Office Action Summary

DETAILED ACTION

App No.: 09/857,348
Docket No.: 43315-212951
Inventor: Persson et al.
Title: ROBOT DEVICE

FIG. 4

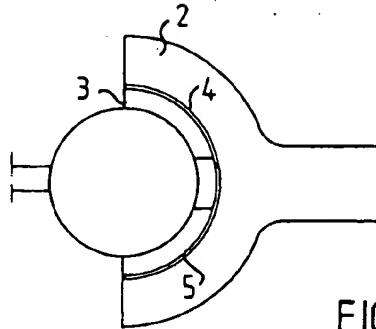
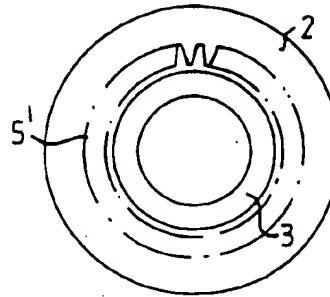
The drawings are objected to under 37 CFR 1.84(h)(5) because Figure 4 shows modified forms of construction in the same view. The two separate images associated with the label "FIG.4" should each be separately labeled as --FIG.4a-- and --FIG.4b--, respectively. See 37 CFR 1.121(d).

The applicant argues that the drawings show the bearing member installed in the socket which in and of itself is enough to satisfy a showing of the grooves engaging and deforming the bearing member. This is not persuasive. It is not necessary for a bearing member that is being installed in a socket to be so installed through deformation. The applicant's drawings do not

depict any process of deformation nor do they depict any final product structure unobtainable from a non-deforming assembly procedure (i.e. a bearing member preformed to fit grooves). Moreover, given the extreme informal nature of the drawing, it is not even clear what is being illustrated or if what is illustrated is accurate.

The applicant argues that Latzen does not teach a bearing member that engages a portion of a distal half of the joint ball not adjacent the rod the ball is connected to. This is not persuasive. Since the limitation “not adjacent the rod the ball is connected to” is not recited in the claims. Latzen teaches a bearing member engaging a portion of a distal half (right half) of the joint ball as detailed in the prior art rejections above. Furthermore, note that if the claims were to be amended to define the distal and proximal halves as being opposite and adjacent from the rod, respectively, then the applicant’s own invention would not engage “at least a portion of a distal half of each joint ball and at least a portion of a proximal half” as currently claimed (see applicant’s figure 4 which clearly shows the bearing contacting only 1 half of the ball).
